Figure 2

BECHTEL SAN FRANCISCO		
DUANE ARNOLD ENERGY CENTER - UNIT NO 1 IOWA ELECTRIC LIGHT AND POWER CO. CEDAR RAPIDS IOWA		
ISOMETRIC - REACTOR BUILDING CONTAINMENT ATMOS. CONTROL		
JOB NO.	DRAWING NO.	REV.
7884	HLE-25-1	5

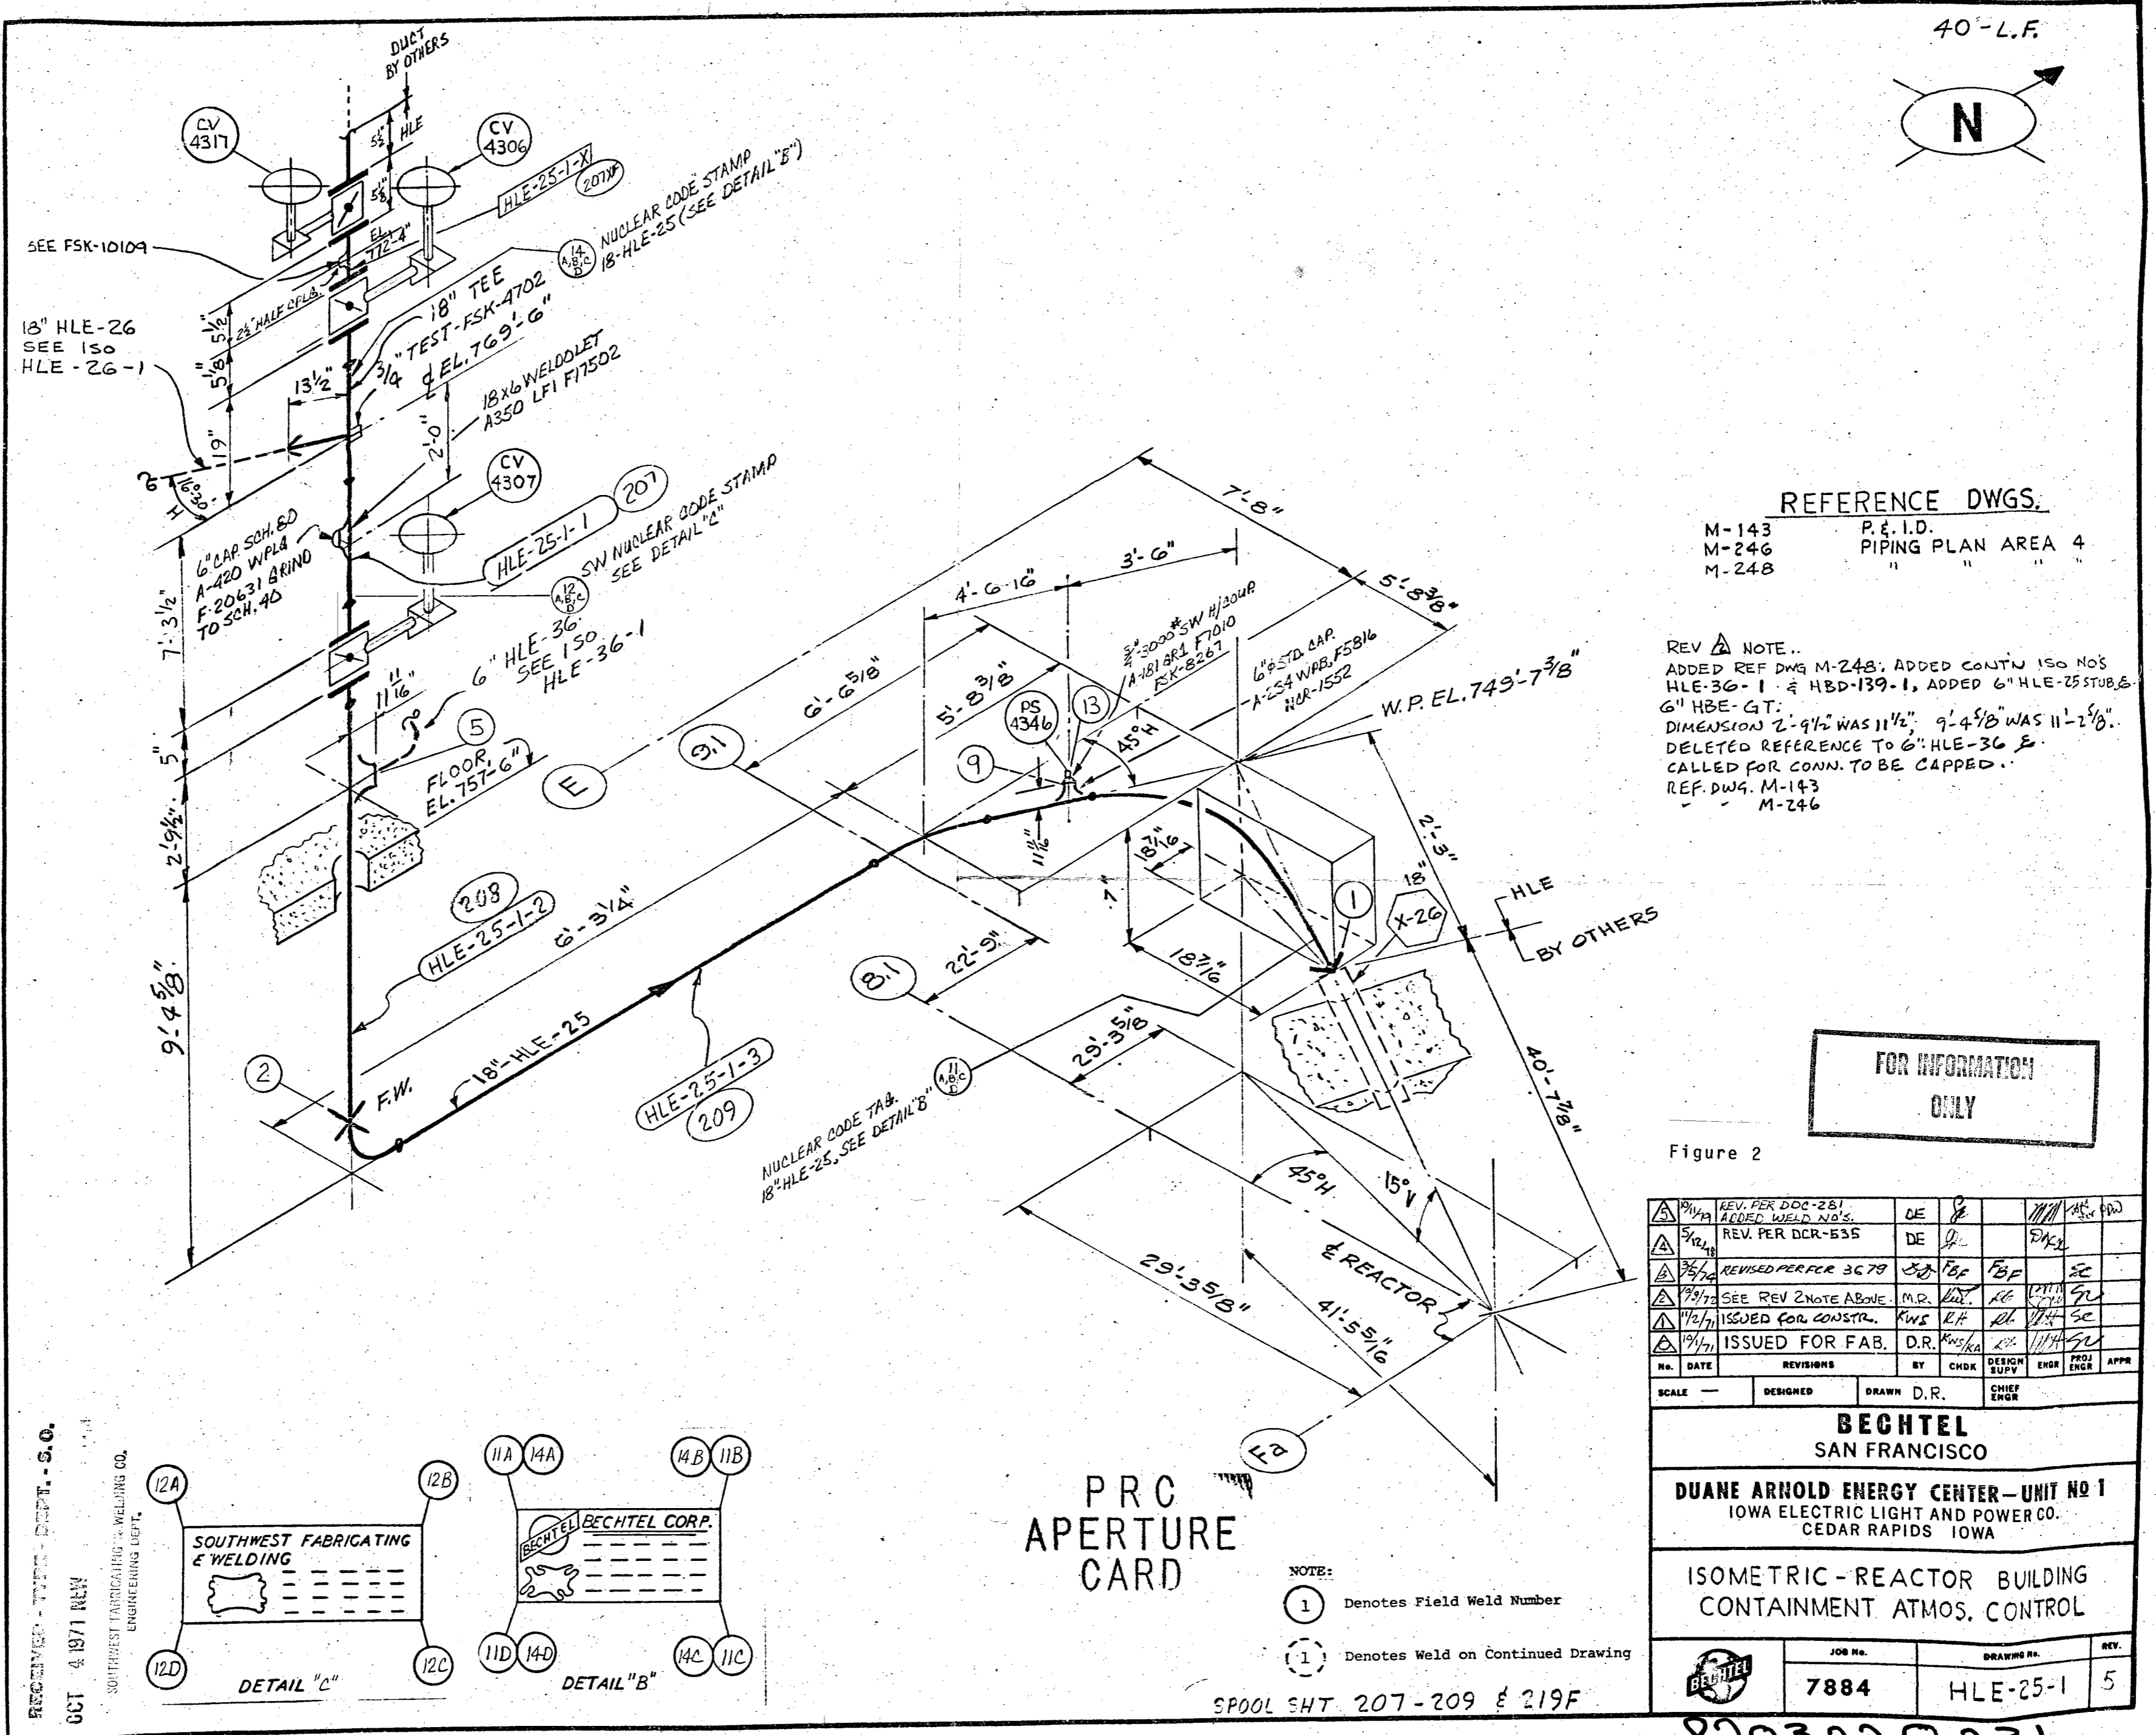
REV A NOTE..
ADDED REF DWG M-248; ADDED CONTN ISO NOS
HLE-36-1 & HBD-139-1, ADDED 6" HLE-25 STUB &
6" HBE-GT.
DIMENSION 2'-9 1/2" WAS 11 1/2"; 9'-4 5/8" WAS 11'-2 5/8".
DELETED REFERENCE TO 6" HLE-36 &
CALLED FOR CONN. TO BE CAPPED..
REF. DWG. M-143
M-246
